CUSTOMER TECHNICAL MEMO # 203

Subject: MF101 Stainless Steel Storm Grate

Date: 7-05-2014

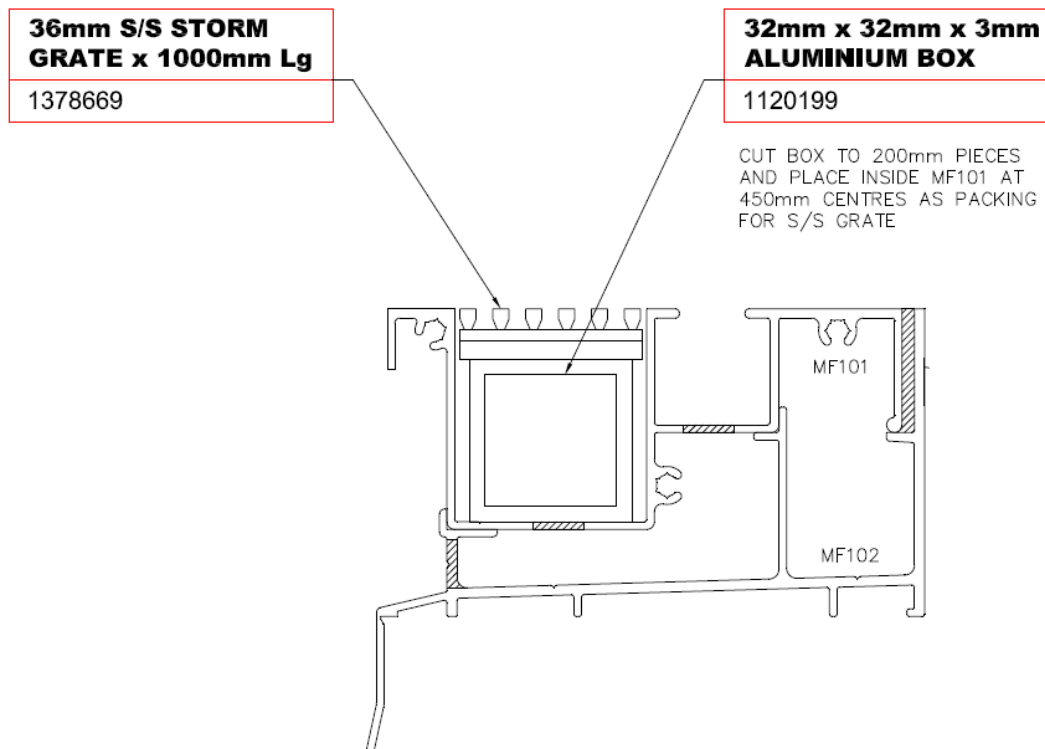
The item 1396040 – 38A STORMTECH SS GRATE 1200mm is no longer available.

The alternate is to use the 1378669 - PRG018 ALSPEC 36mm STORM GRATE 1000mm that we use in ProGlide. You will need to fit 1120199 - BOX SQUARE 32mm x 3mm under the grate as packers, we suggest that the box be cut into 200mm pieces and dropped into the MF101 at 450mm centres to support the PRG018 ALSPEC 36mm STORM GRATE.
